LOCATION 3 Cherry St

TO: Inspections
FROM: Jay Reynolds, Development Review Coordinator
DATE: November 2, 2001
RE: C. of O. for # 3 Cherry Street

DATE: 18/June/96 ADDRESS: 3 Cherry ST.
 REASON FOR PERMIT: To Construct a single family dwelling.
 BUILDING OWNER: Jonel Pastolacke
 CONTRACTOR: 11 11 11 APPROVED: *1*7*9*11
 PERMIT APPLICANT: 11 11 ~~REVIS~~: *13*14*15*16.

RE: Postolache Residential Property at 3 Cherry Street, Portland, ME

2-4-97
3 Cherry St.

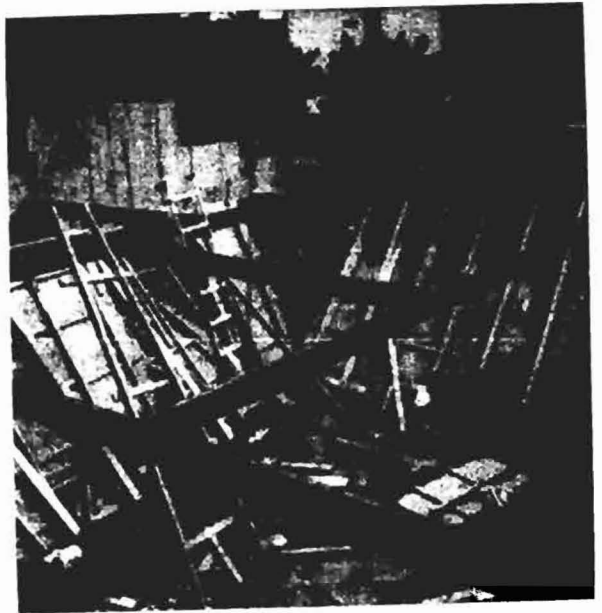
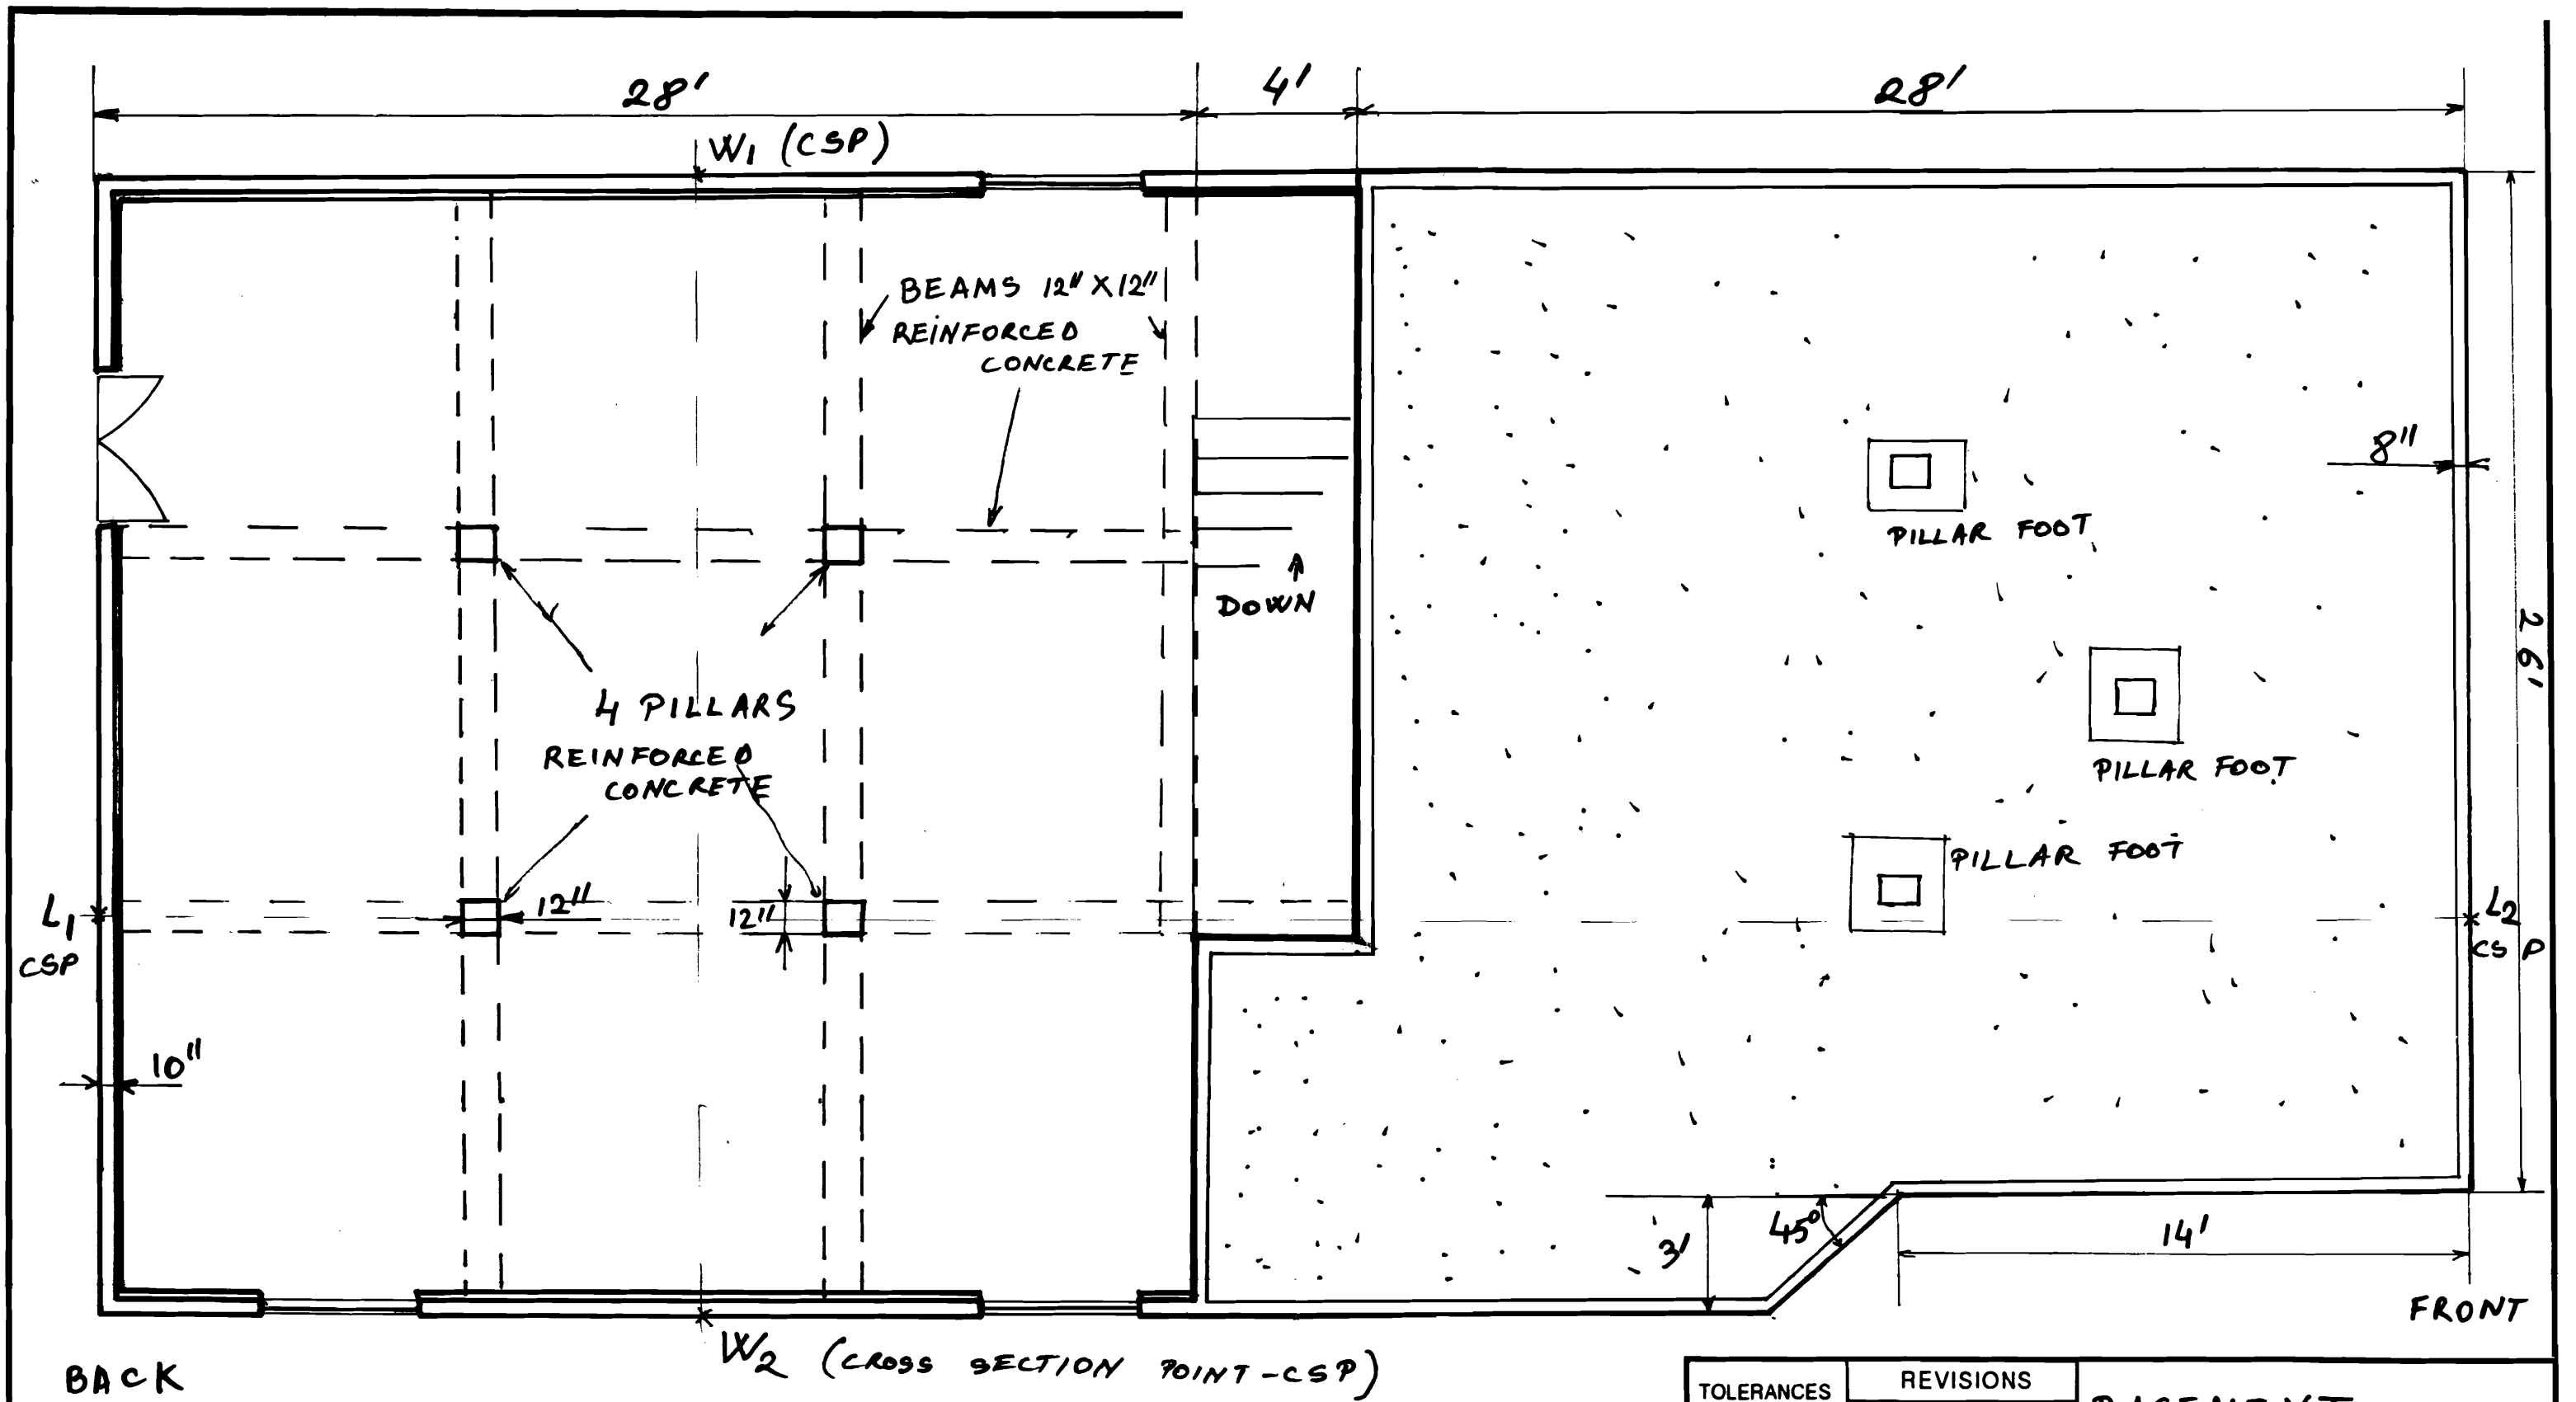
2-4-97 - Insp Site covered w/snow I feel unsafe walking on roof, porch & in basement took pictures cannot determine if brackets has meet requirements of Report 11-16-96 (see Sam H. Hises) does not appear any work performed since 1-24-97 insp / Mr Postolache stated to me - did the wall's were going to be used as part of column supports? (none of them called)
